NM1 - 53

**RE: Request for Additional Information – Permit Application Review for a Proposed Commercial Surface Waste Management Facility
Envirotech, Inc. – Landfarm #4
Facility Location: Sections 6, 7, and 8, Township 26 North, Range 10 West, NMPM
San Juan County, New Mexico**

Request for Additional Information
Envirotech, Inc. – Landfarm #4
Commercial Surface Waste Management Facility
March 24, 2011

Vicinity Map

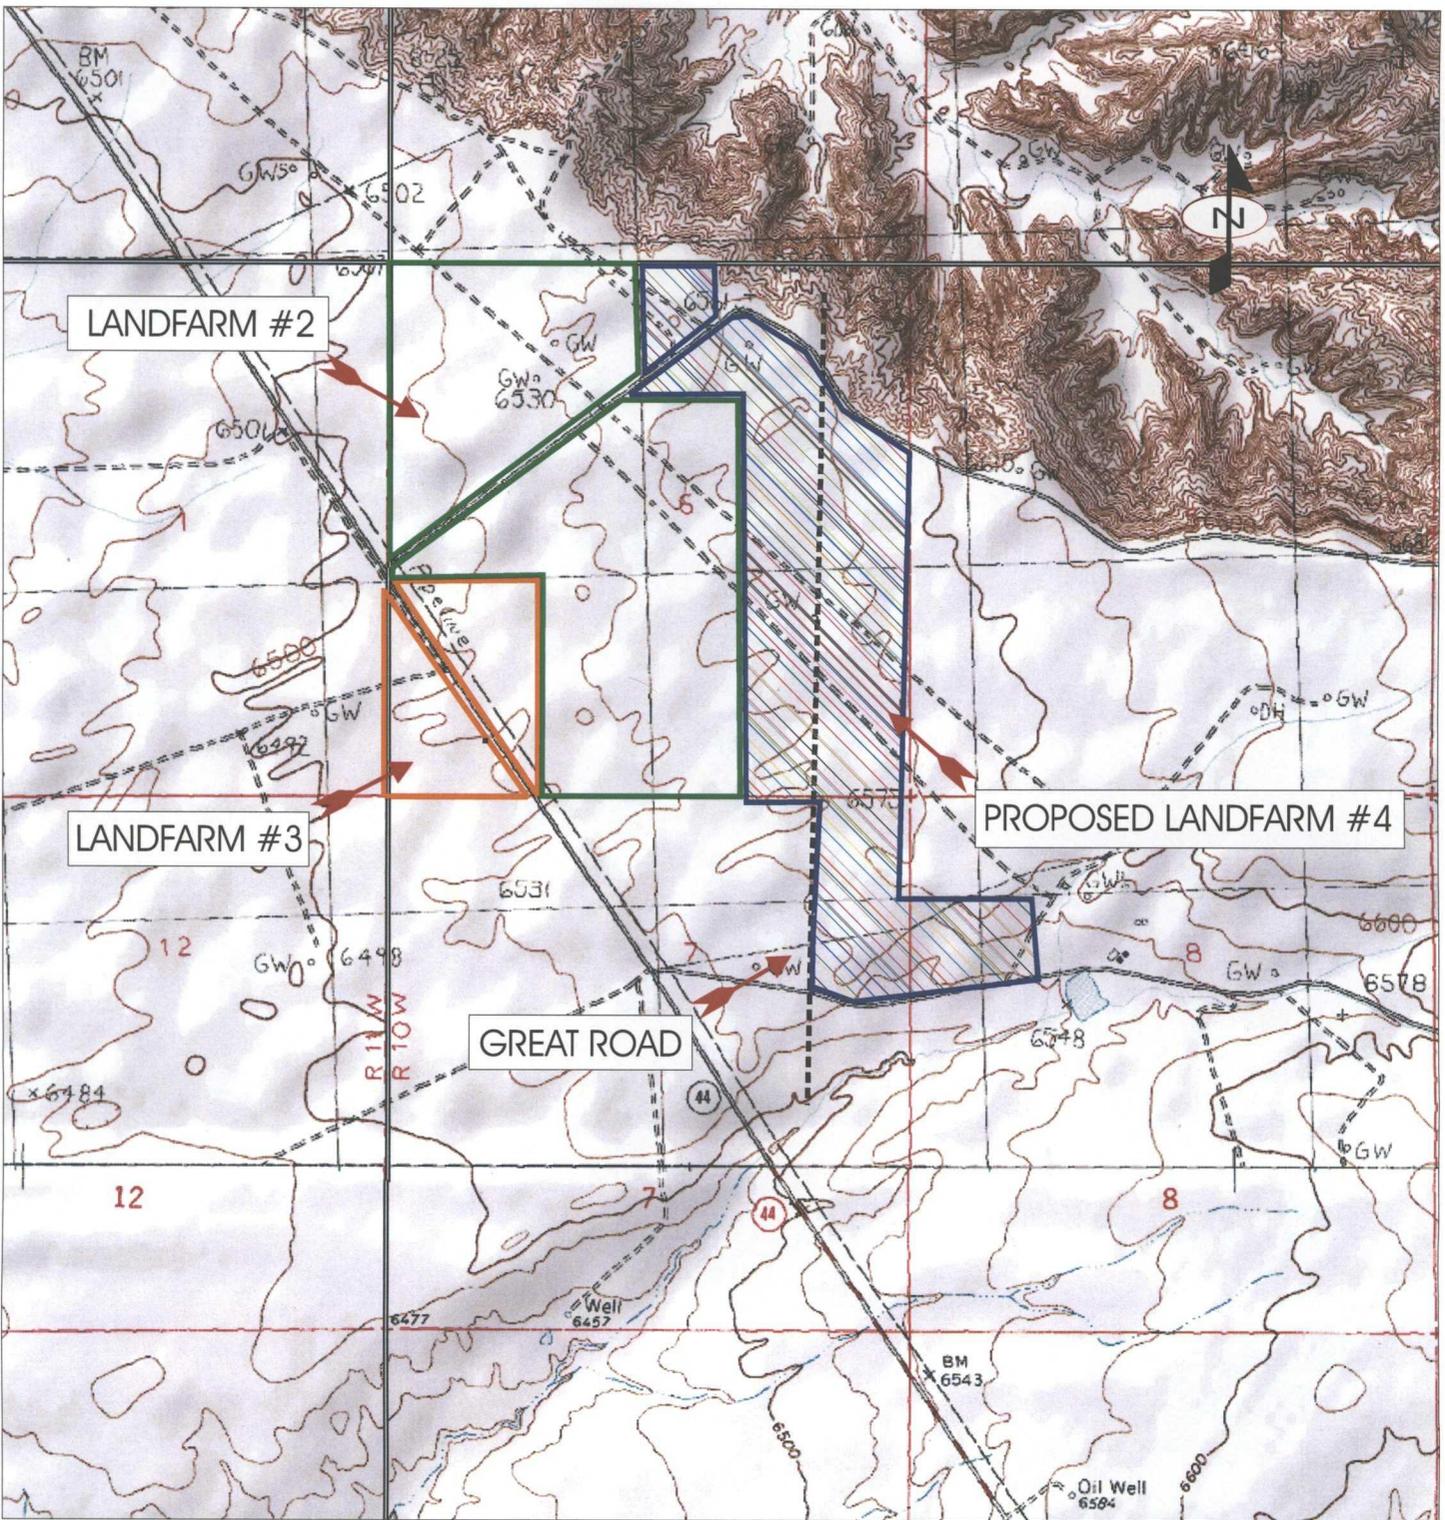
Pursuant to Paragraph (4) of 19.15.36.8.C NMAC, the application shall include “*a description of the surface waste management facility with a diagram indicating the location of fences and cattle guards, and detailed construction/installation diagrams of pits, liners, dikes, piping, sprayers, tanks, roads, fences, gates, berms, pipelines crossing the surface waste management facility, buildings and chemical storage areas.*” The response provided for Item 10 of the Form C-137 identifies Attachment 3 as the demonstration of compliance to this provision. The only item provided in Attachment 3 was a survey map of the proposed facility. The map illustrates an entrance from the south into the large eastern section of the proposed landfarm. This entrance was not identified on the Vicinity Map provided in Attachment 1. Neither map

demonstrates how this entrance will be assessed from U.S. Hwy. 550. The Vicinity Map provided in Attachment 1 is required to demonstrate "*or roads giving access to the surface waste management facility site.*" Please modify the Vicinity Map provided in Attachment 1 and the survey map provided in Attachment 3. There is also a comment provided just above the southern entrance on the survey map which states "Limits of Landfarm- 100' buffer typical all outside property line." Pursuant to Paragraph (2) of 19.15.36.15.C NMAC, "the operator shall not place contaminated soils received after the effective date of 19.15.36 NMAC within 100 feet of the surface waste management facility's boundary." The 100 foot buffer is required to be within the facility boundary. Also, please provide "*a description of the surface waste management facility*" and "*detailed construction/installation diagrams of pits, liners, dikes, piping, sprayers, tanks, roads, fences, gates, berms, pipelines crossing the surface waste management facility, buildings and chemical storage areas*" as required by this provision.

Facility Diagram and Description

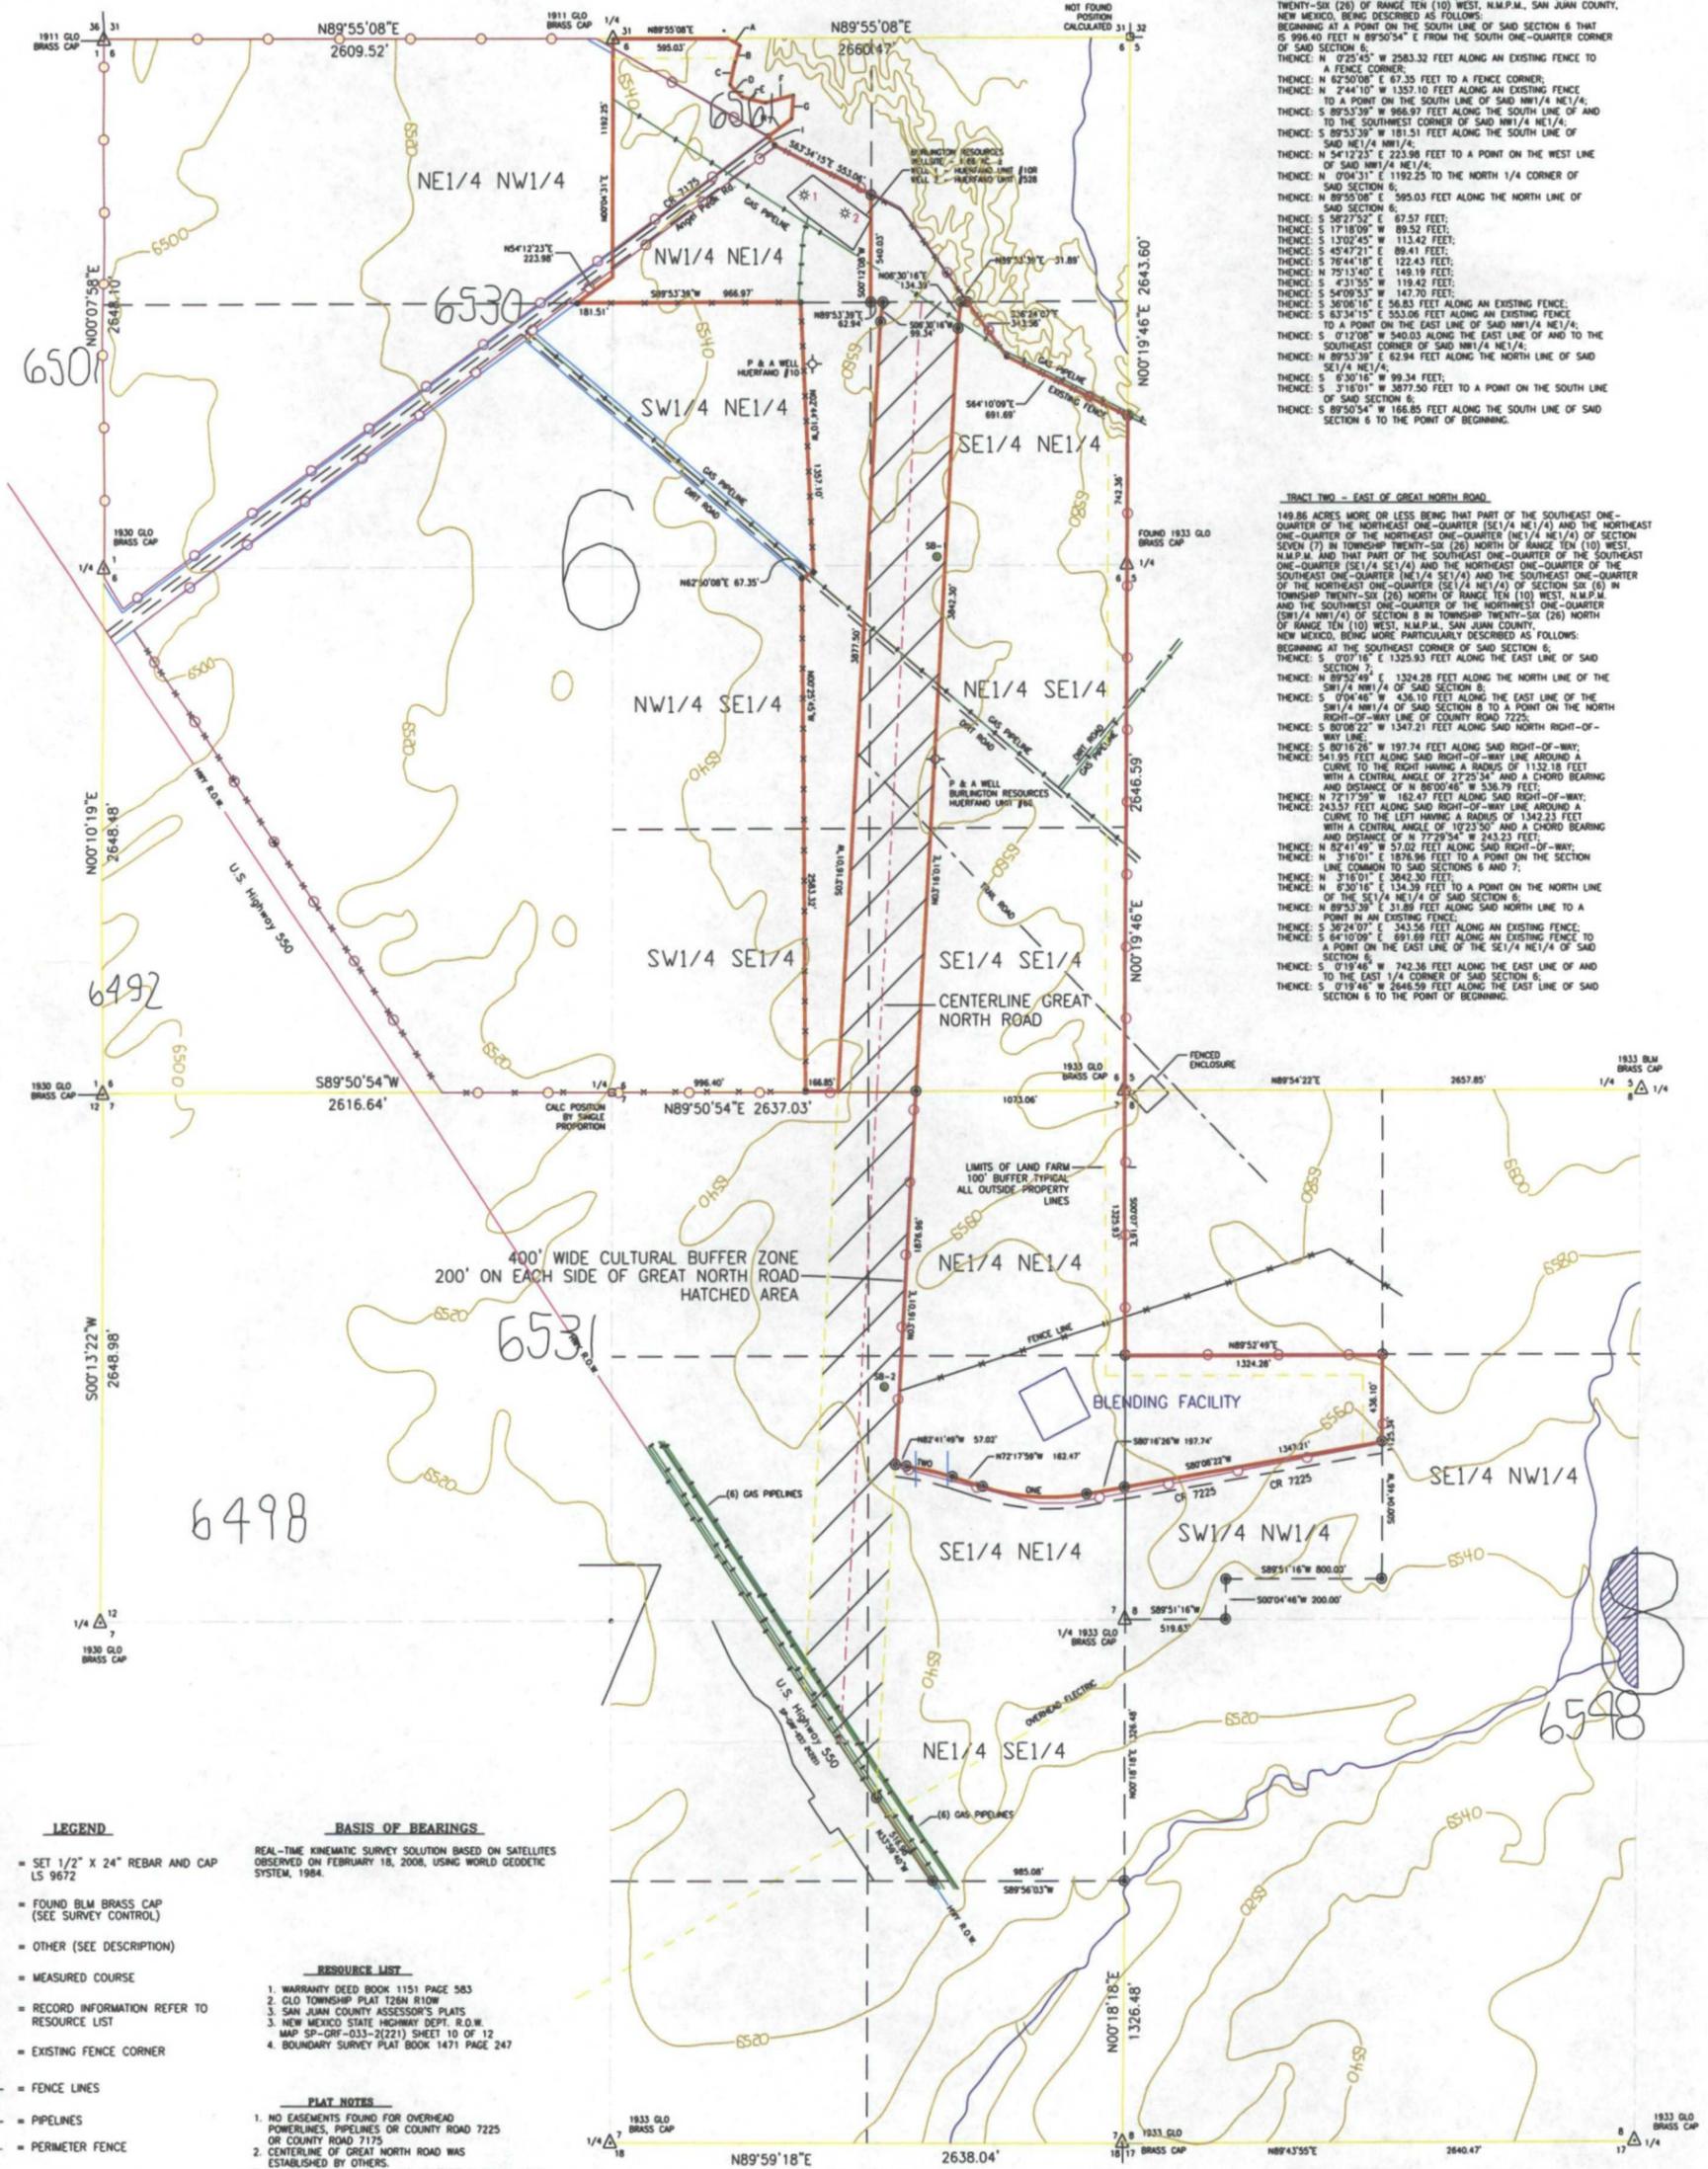
19.15.36.13.C: The response provided for this provision states that the proposed surface waste management facility “is 189 acres” and references Attachment 3 as the demonstration. The only item provided in Attachment 3 is a survey map of the proposed facility. The survey map provided in Attachment 3 illustrates two separate tracts. The area of Tract 1 is identified as “57.75 acres more or less” and Tract 2 is identified as “149.86 acres more or less” for a total of 207.61. Please clarify.

The introductory paragraph for this section of the closure plan describes the size of the proposed surface waste management facility as "189 acres." The survey map provided in Attachment 3 illustrates two separate tracts. The area of Tract 1 is identified as "57.75 acres more or less" and Tract 2 is identified as "149.86 acres more or less" for a total of 207.61. Please clarify and make the appropriate adjustment throughout the permit application and this section. The last sentence of the paragraph states that the "remaining nineteen (19) cells will be in discontinued maintenance status for this analysis." The term "discontinued maintenance status" is not a term found or used in 19.15.36 NMAC. It is a term used in approvals associated with surface waste management facilities permitted prior to the effective date of 19.15.36 NMAC. Pursuant to Paragraph A of 19.15.36.20 NMAC, Transitional Provisions, "Existing surface waste management facilities shall comply with the operational, waste acceptance and closure requirements provided in 19.15.36 NMAC, except as otherwise specifically provided in the applicable permit or order, or in a specific waiver, exception or agreement that the division has granted in writing to the particular surface waste management facility." The term "discontinued maintenance status" is not applicable to the permit application since it is for a new surface waste management facility. Pursuant to

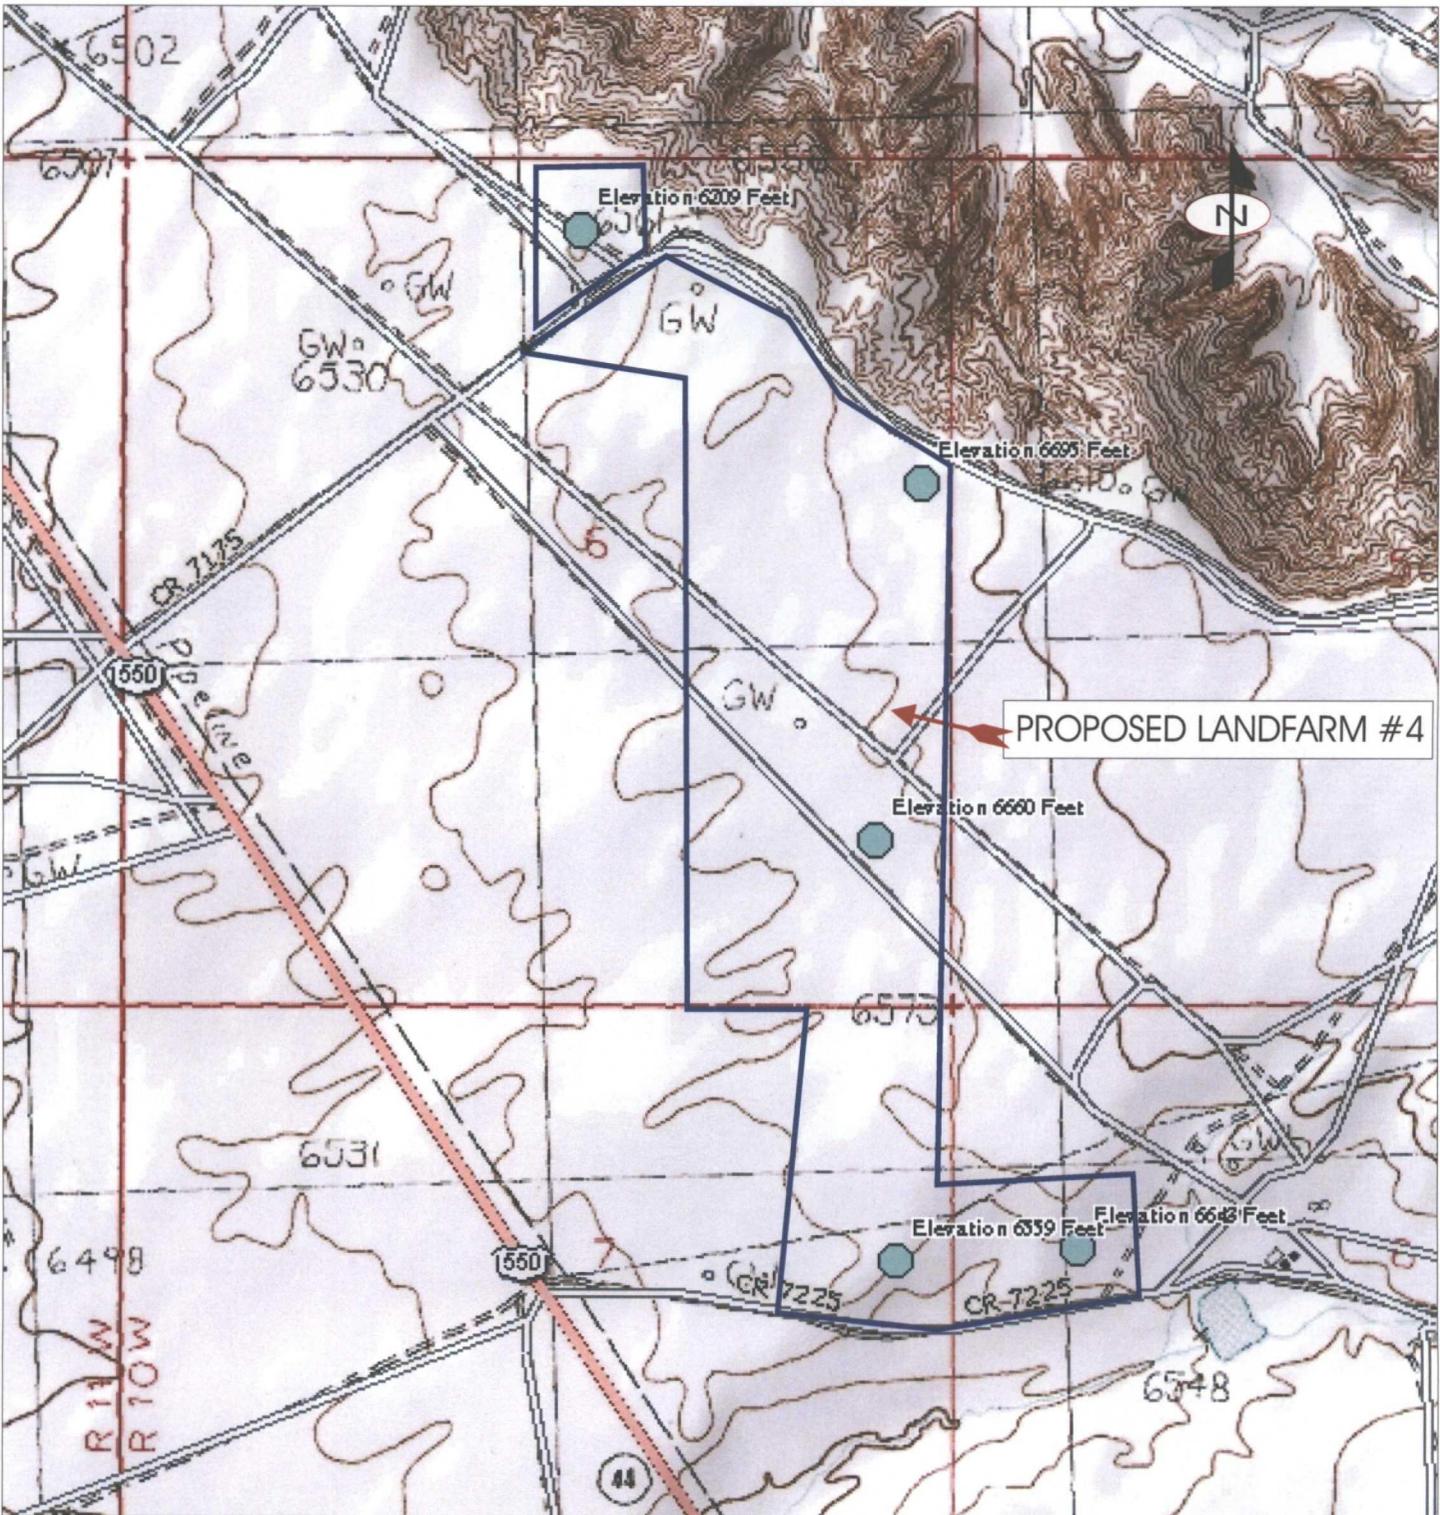
Figure 1, Elevation Data Locations: Please explain why the measured elevations illustrated on this map do not coincide with the elevation illustrated on the survey plat provided in Attachment 3 of the permit application. Please explain and clarify why different elevations are assigned to the same locations. Is the survey plat not accurate?
